27" C.A.R.T. Fury Dedicated Video Game Amendment

Please be informed of the following changes...

Main Cabinet Wiring

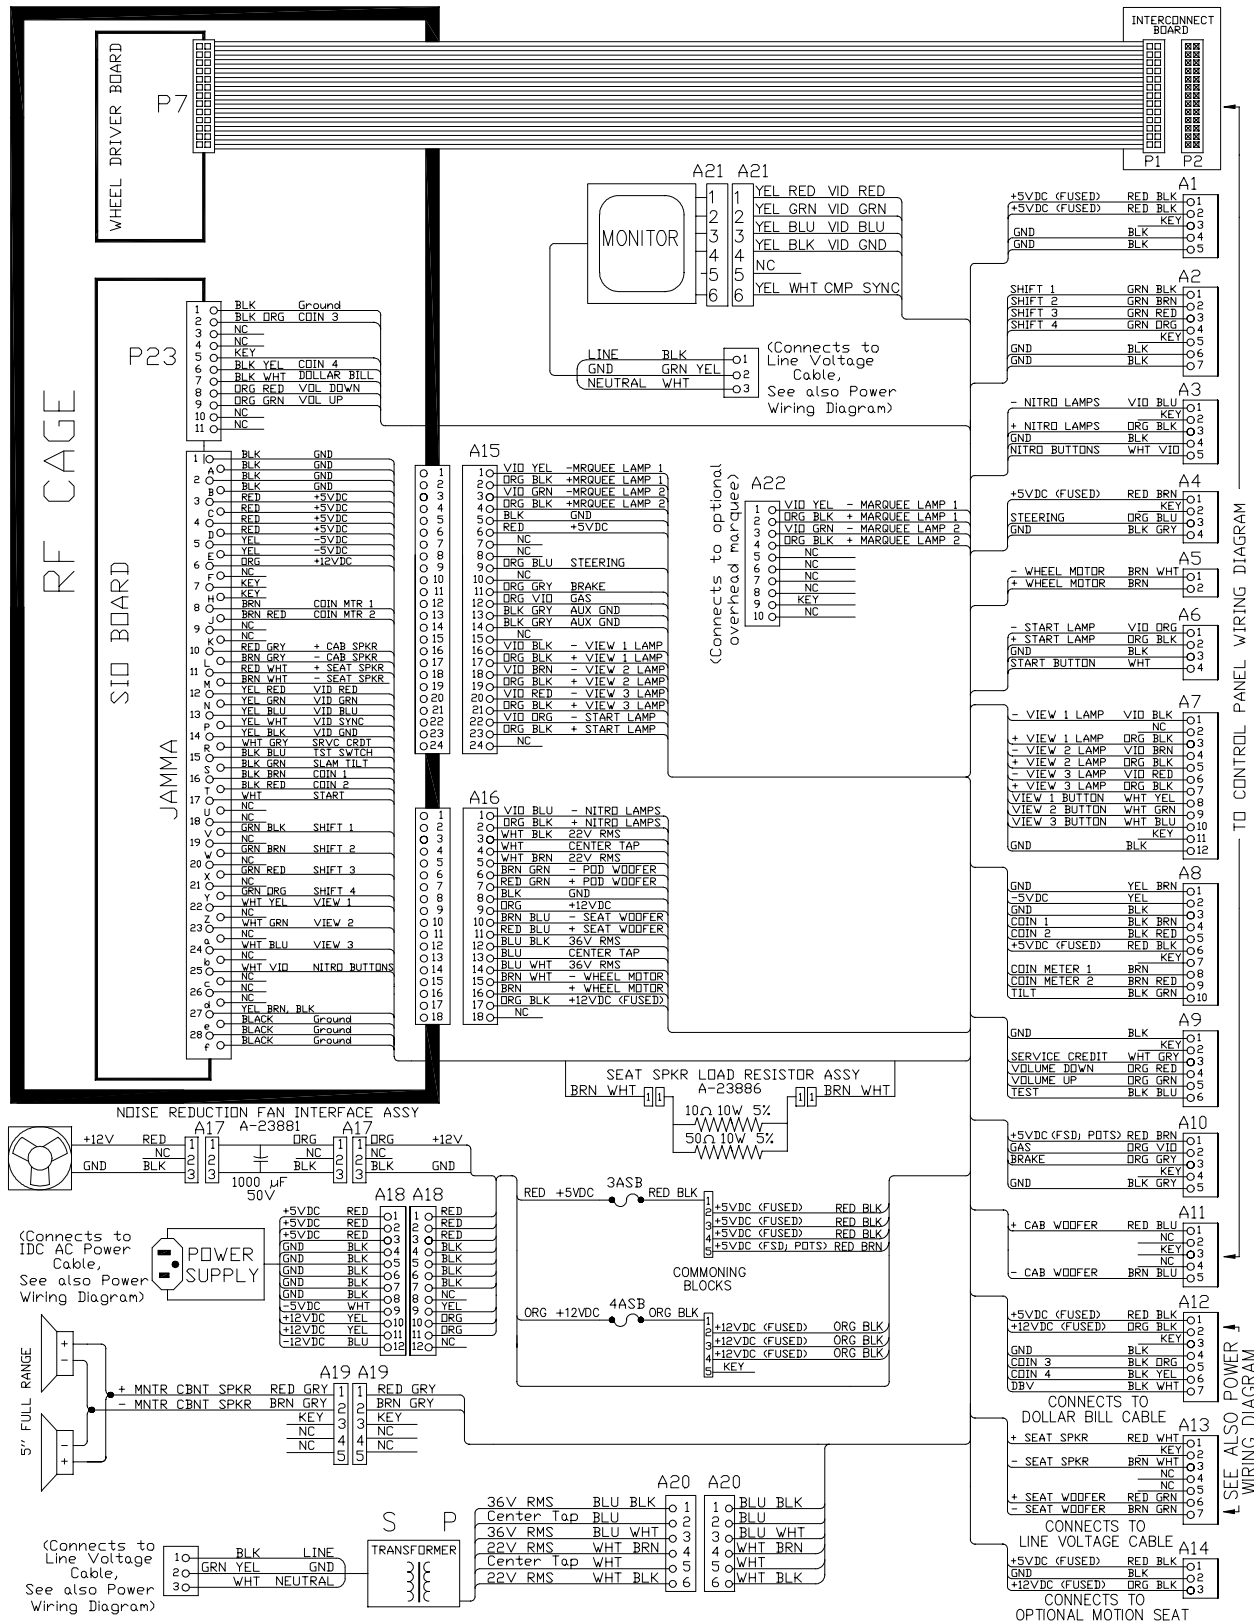
II. Wiring diagrams as shown in the 27" Dedicated C.A.R.T. Fury™ manual (16-40090-101) are incorrect due to recent revisions.

Please refer to page 2 through 5 for information regarding main cabinet, RF cage, control player panel, and power wiring diagrams.
